**AMENDMENTS TO THE DRAWINGS:**

**REMARKS**

Fig. 5

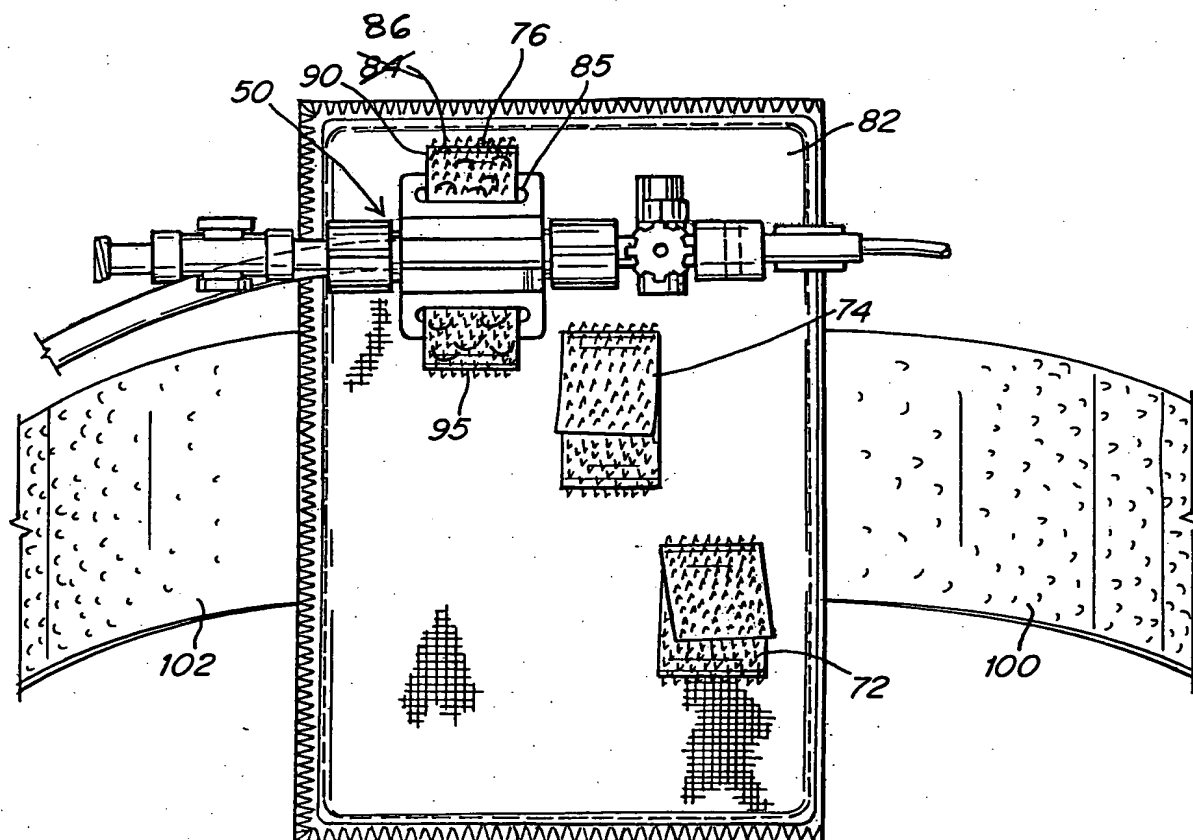
Subject to the approval of the Examiner, Applicants propose correcting FIG. 5 by changing reference numeral 84 to reference numeral 86, and changing the hook surface to a loop surface, as shown on the annotated sheet. Support for this change can be found in paragraph no. [027] of Applicants' specification ("loop surface 86 faces away from base 82"), and in the informal drawings sheets originally filed with the present application which correctly labeled the surface with reference character 86. No new matter has been added.
